UNITED STATES PATENT AND TRADEMARK OFFICE

APPLICATION NO.	FILING DATE	FIRST NAMED INVENTOR	ATTORNEY DOCKET NO.	CONFIRMATION NO.
16/869,402	05/07/2020	Jason Wersland	76840-5077	4812
24574	7590	07/28/2020		
JEFFER, MANGELS, BUTLER & MITCHELL, LLP 1900 AVENUE OF THE STARS, 7TH FLOOR LOS ANGELES, CA 90067			EXAMINER STUART, COLIN W	
			ART UNIT	PAPER NUMBER
			3785	
			NOTIFICATION DATE	DELIVERY MODE
			07/28/2020	ELECTRONIC

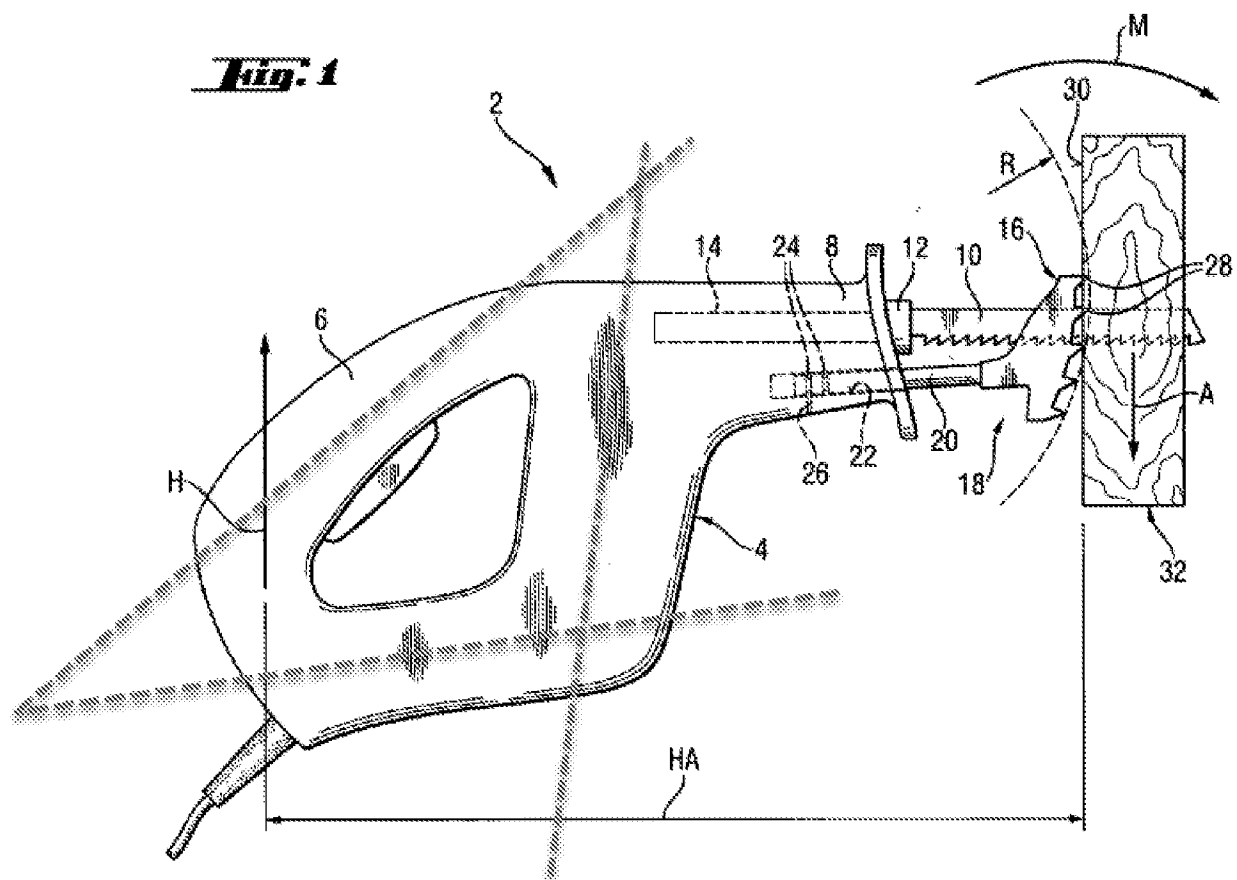
device (note that the device of Rix is a reciprocating saw converted to be a massager as discussed above) which includes handle portions which have an interior edge with length which would allow for a user to grasp such that at least a portion of three fingers extend through the handle opening and contact the interior edge as claimed (see annotated Fig. 1 of Neumeier below which shows the axes defined by three different handle portions all of which define the handle opening via interior edges with lengths which would allow for the user to have at least a portion of three fingers extending therethrough and contacting the interior edge). Thus it would have been obvious to one of ordinary skill in the art before the effective filing date of the claimed invention to modify the modified Rix method's device's handle to be shaped, as taught by Neumeier, in order to provide a desired, ergonomic shape to the handle.

Regarding claim 26, the modified Rix method's housing includes a head portion with the motor positioned therein (see annotated Fig. 1 of Neumeier above and Fig. 1 of Rix, actuated output 18 of Rix is reciprocated via motor 72 which is located in a similar location as a head portion 8 of Neumeier).

Regarding claim 27, the modified Rix method includes at least two of the first, second, and third handle portions being generally straight (see annotated Fig. 1 of Neumeier above).
